HATFIELD MCCOY COMMUNICATIONS, INC.	)	FCC File No. BPH-20120604AAI
for Minor Modification of WVKM(FM), Matewan,	)	FCC Facility ID No. 67039
West Virginia	)	
	)

**INFORMAL OBJECTION**

**ANALYSIS OF WVKM(FM)  
MATEWAN, WV APPLICATION  
BPH-20120604AAI**

**E1**

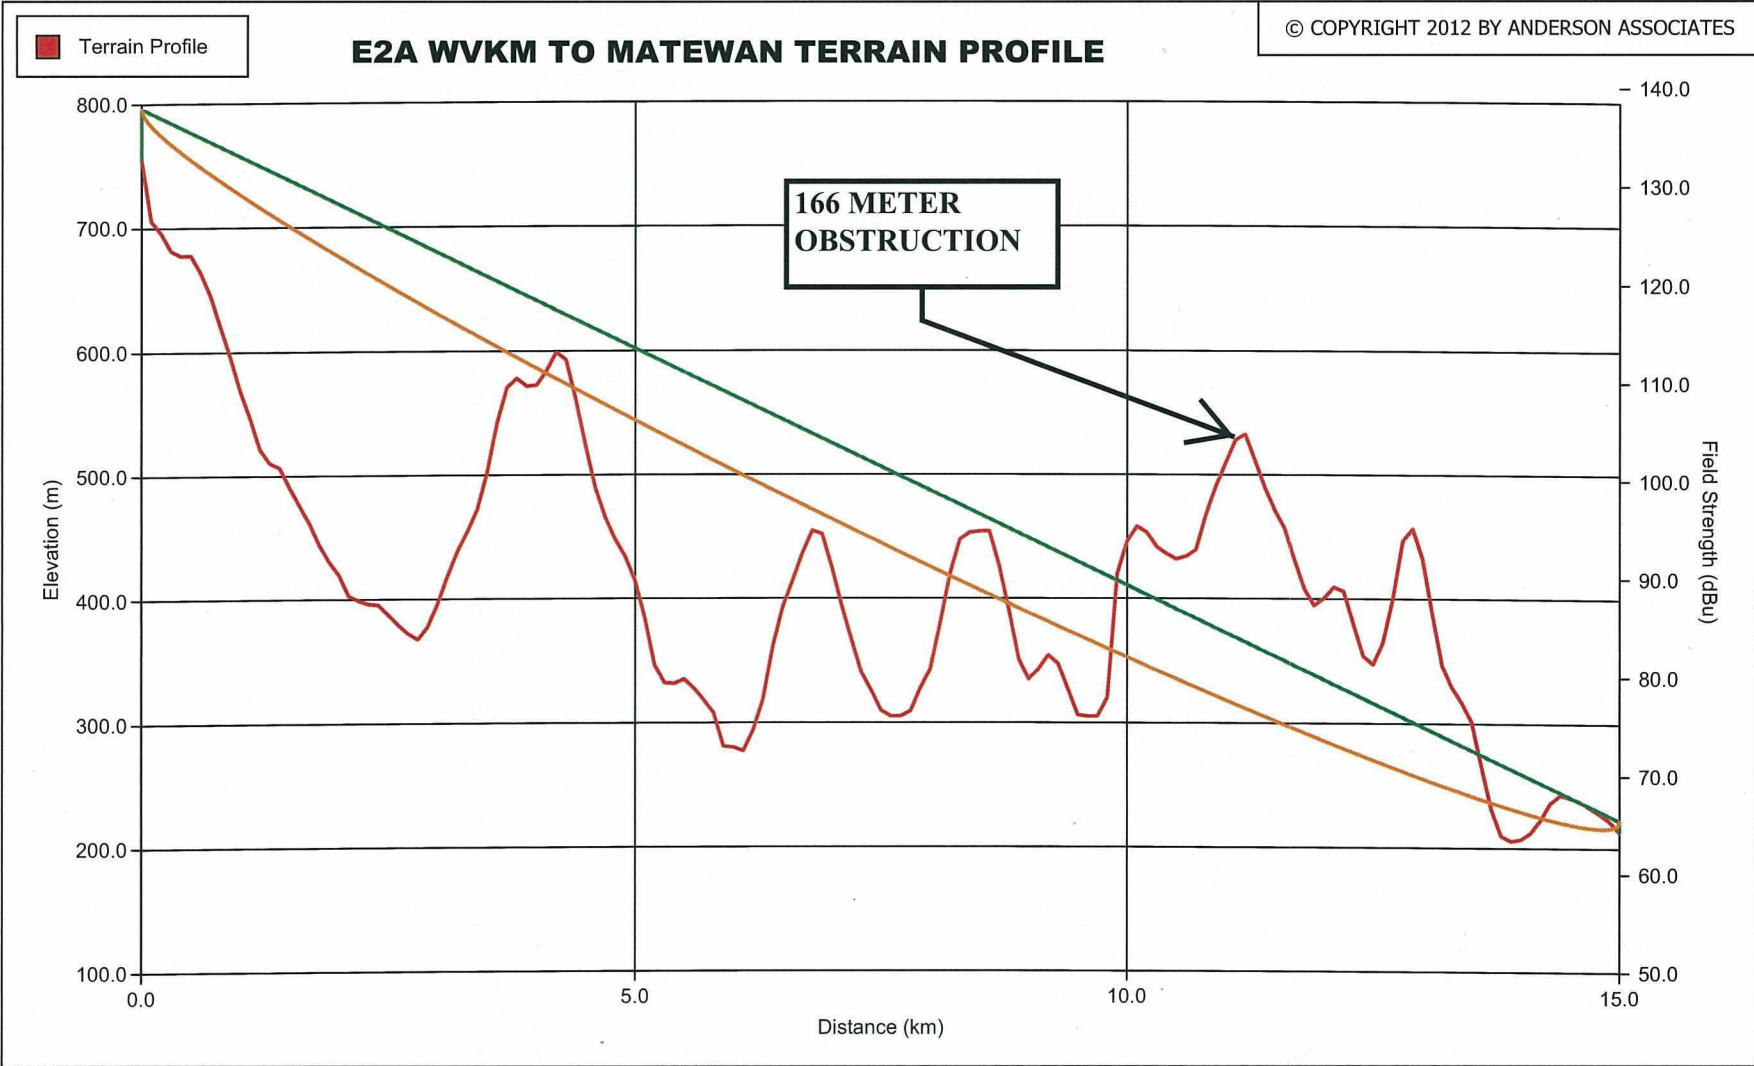
A plots of the FCC Point To Point 70 dBu signal is provided as exhibit E1. The exhibit shows that no portion of Matewan is served by a 70 dBu contour. This exhibit was developed using V-Soft Communications' Probe4 software which incorporates the FCC PTP2 algorithm,

MATEWAN, WV BOUNDARY IS NOT ENCOMPASSED BY THE FCC PTP2 70 DBU CONTOUR.

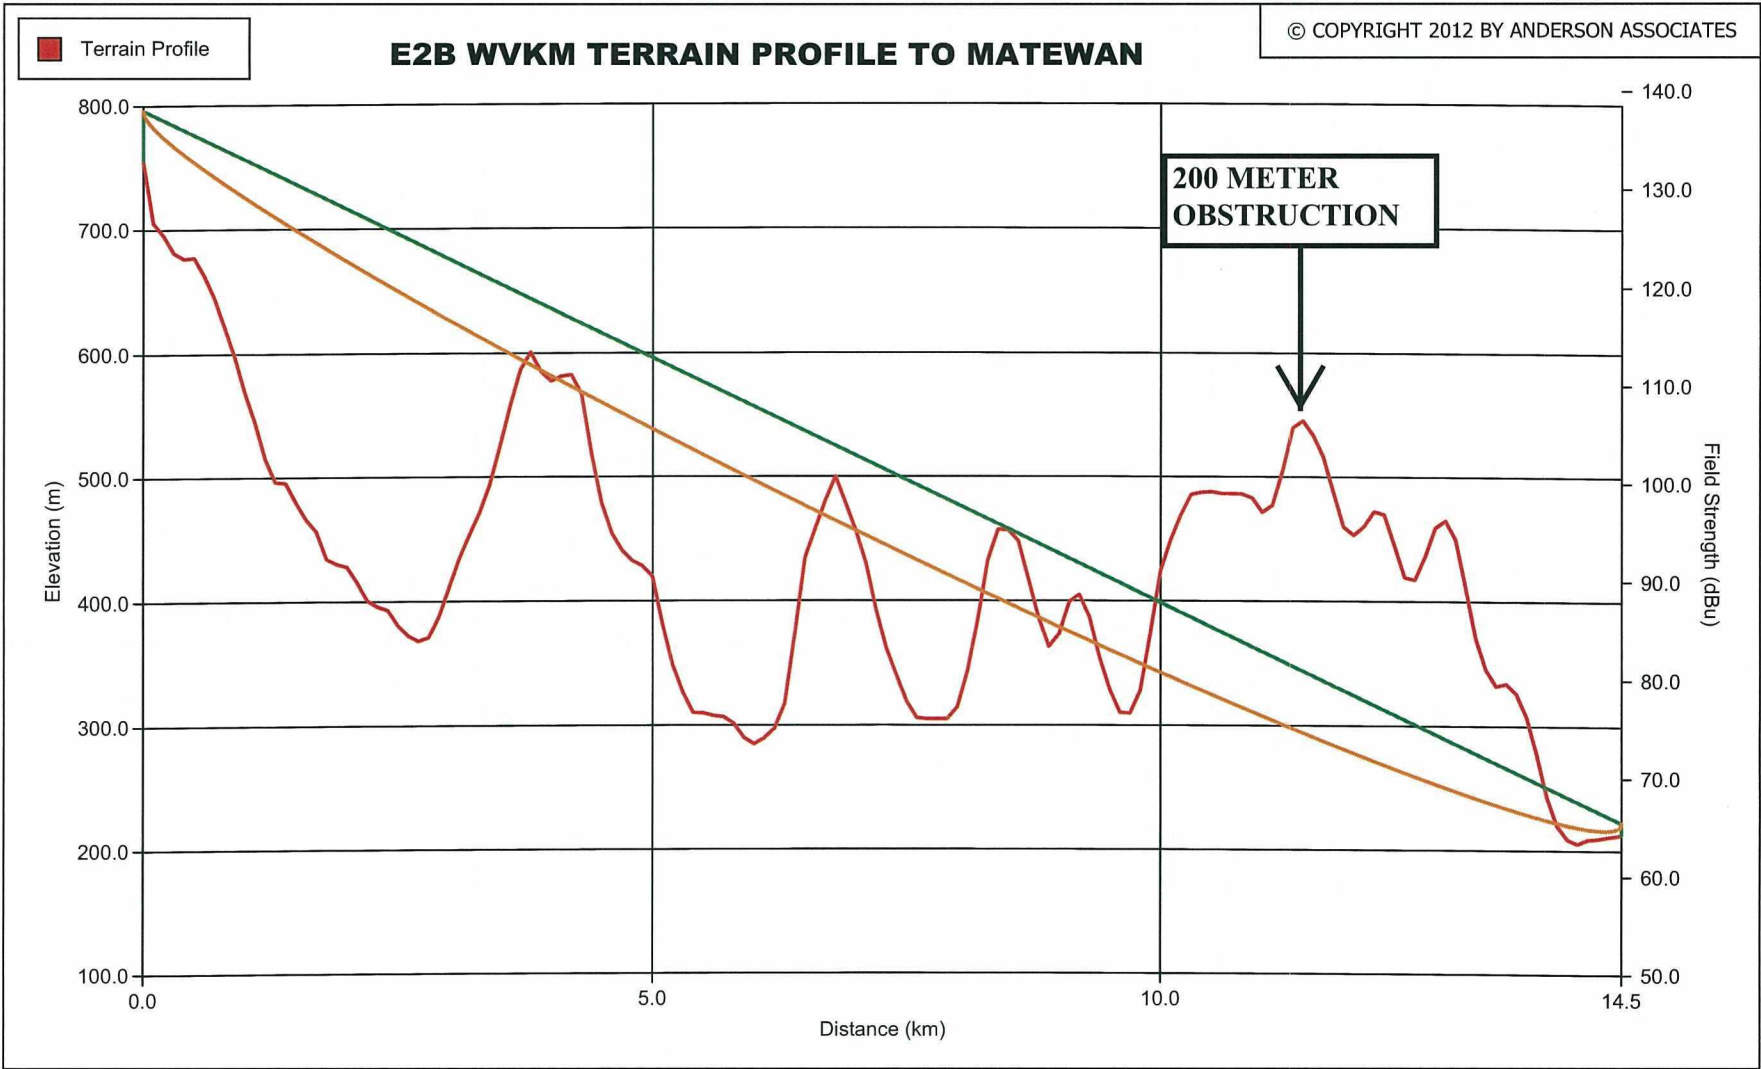
Specifically, there are substantial terrain obstructions to Matewan. Exhibit E2A shows two major obstructions of 166 meters and 160 meters on the 17.0 degree azimuth and exhibit E2B shows a peak obstruction of 200 meters with a width of 2 km on the 18.1 degree azimuth to Matewan. This is clearly in contravention of § 73.315(a) and (b) (see excerpted rules below). The terrain obstructions prevent the delivery of a 70 dBu contour over any part of the community based on the use of the FCC Point To Point Version 2 methodology. This method is appropriately used in cases of major terrain obstructions and has been routinely accepted by the Commission.
